ORIGINATION FORM

Proposed Revisions to a Standard Plans Index

Index Number: 400-011
Sheet Number (s): 1 of 1
Index Title: Gravity Wall

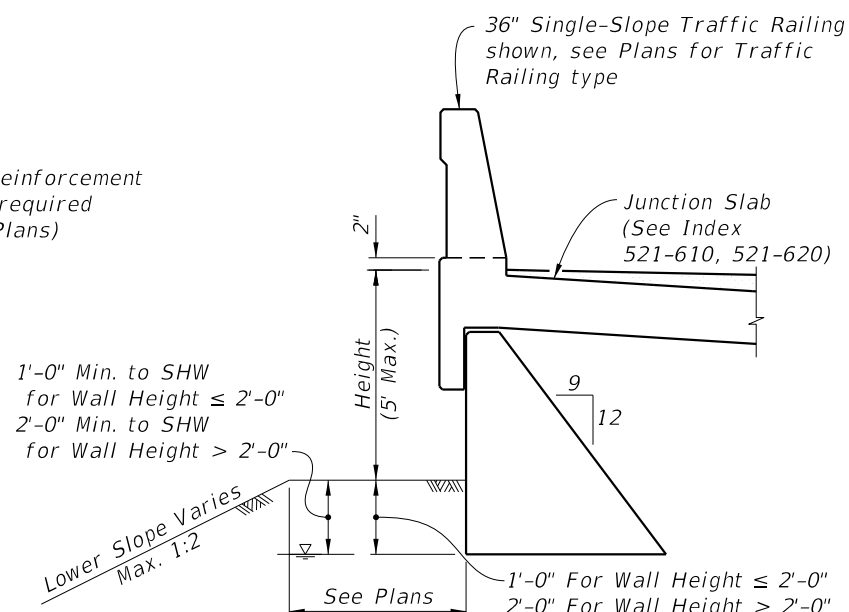
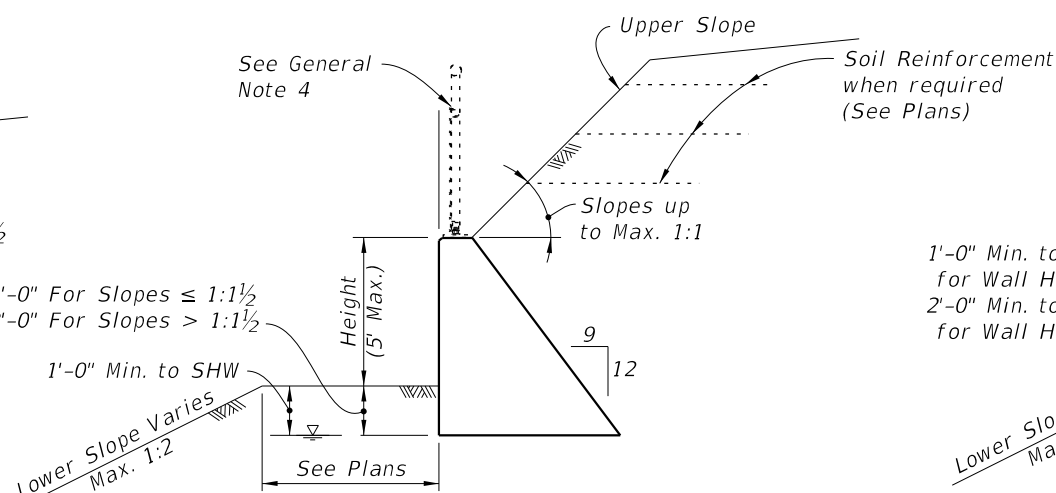
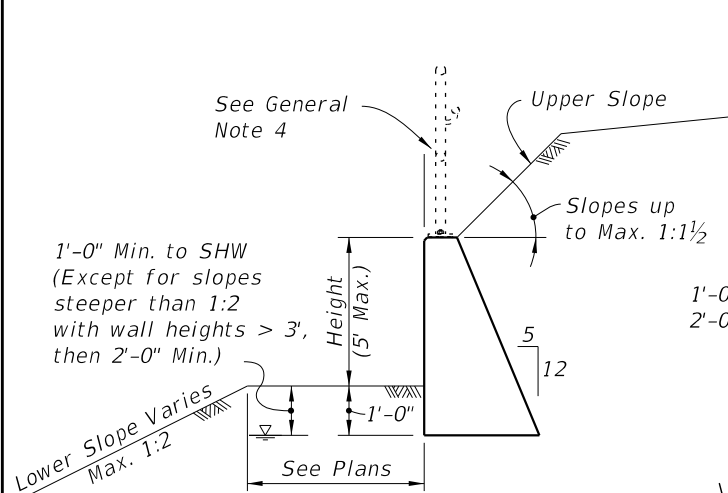
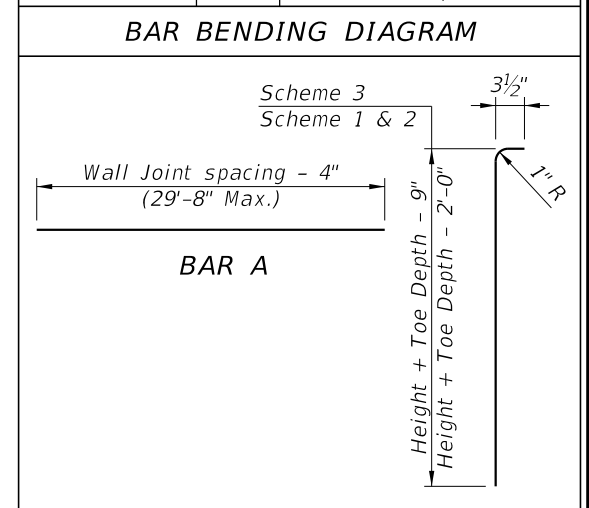
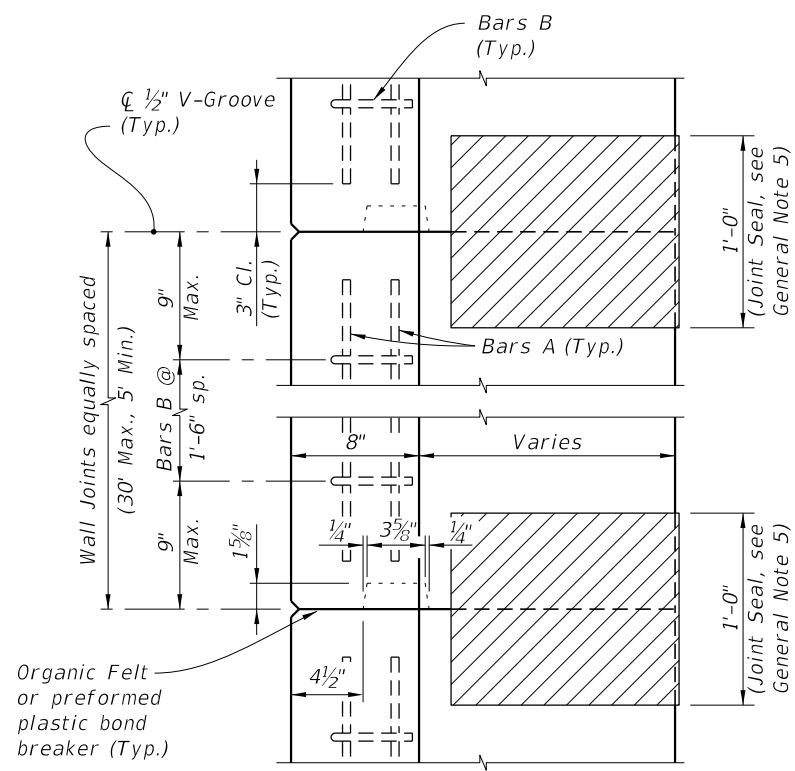
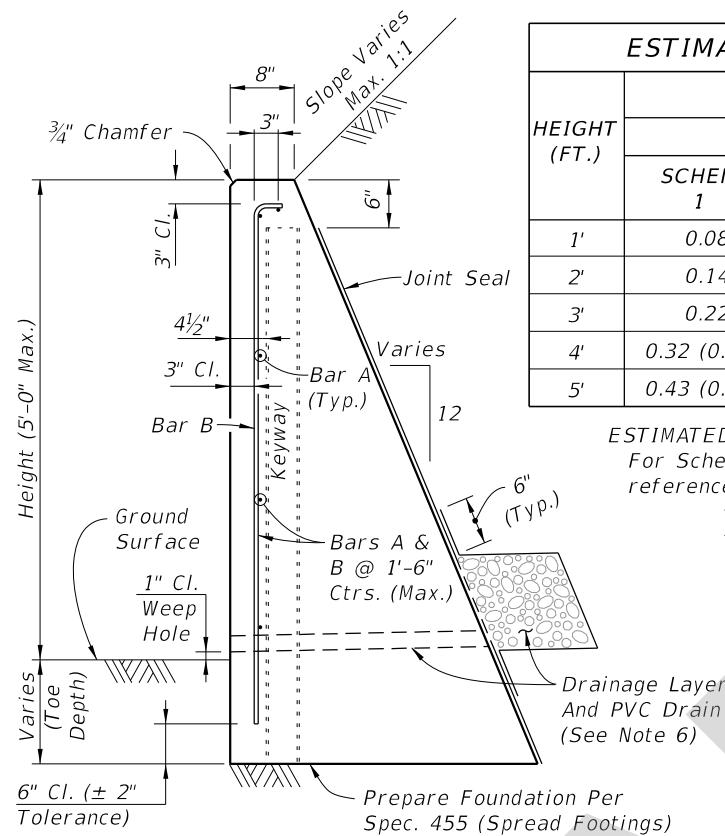
UPDATED: Joint Seal: Provide and install organic bond breaker or Type D-5 geotextile in accordance with Specifications 400 and 514, respectively.

514

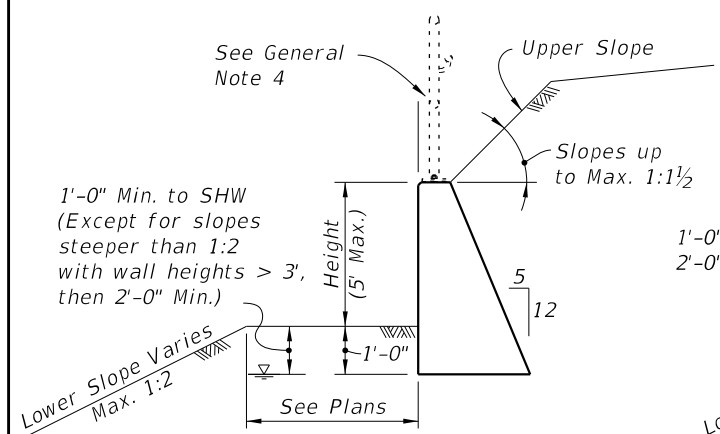
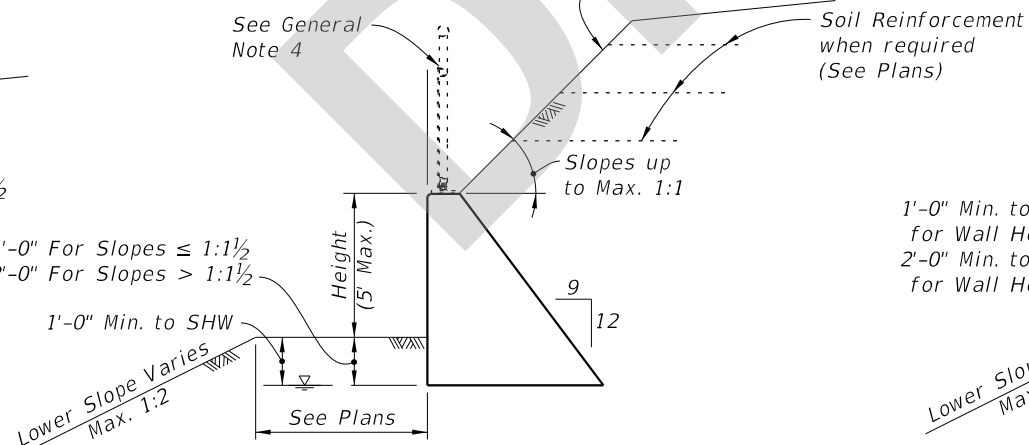
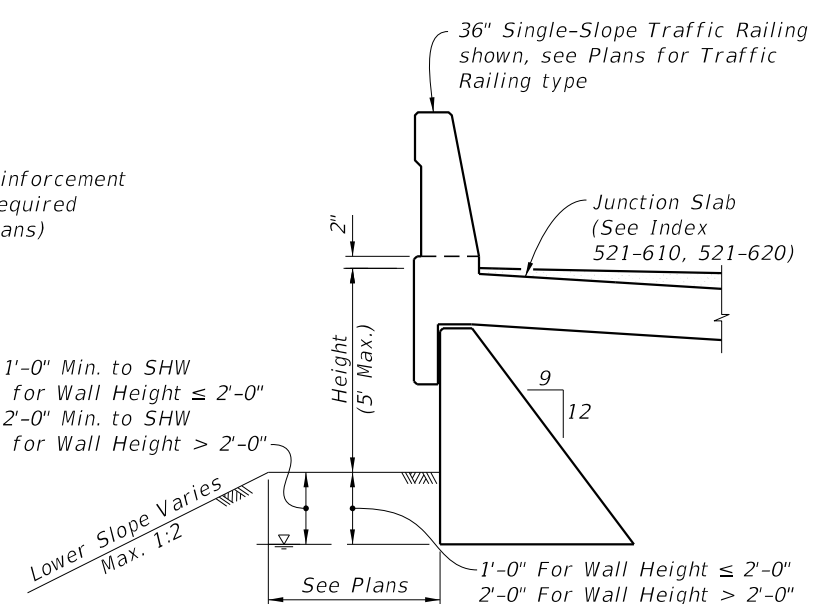
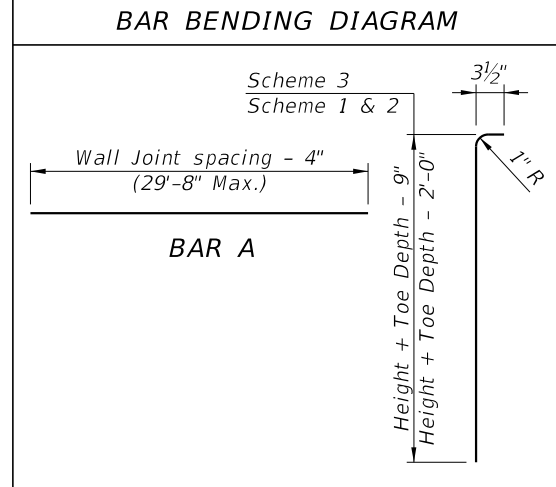
- When required, for adjunct guiderail, see Index 515-070 or 515-080 as appropriate. For adjunct Type B fence see Index 550-002.
- Joint Seal: Provide and install organic bond breaker or Type D-5 geotextile in accordance with Specifications 400 and 514 respectively. Mop all contact surfaces of concrete and Organic Felt or geotextile with cut-back asphalt. Stop Organic Felt or geotextile 6" below top of wall.

- Provide a continuous 1'x1' clean gravel or crushed rock drain for wall heights 3 ft. and higher. Wrap drainage layer as shown, with Type D-3 geotextile in accordance with Specification 514. Provide 8"x8" galvanized mesh with 1/4" openings, at the inside end of the PVC Drain Pipe. Provide 2" Ø PVC Drain Pipe (Sch. 40) at 10 ft. max. spacing (when Drainage Layer is required). Locate outermost edge of Drain Pipe a minimum of 2'-0" from wall joints.
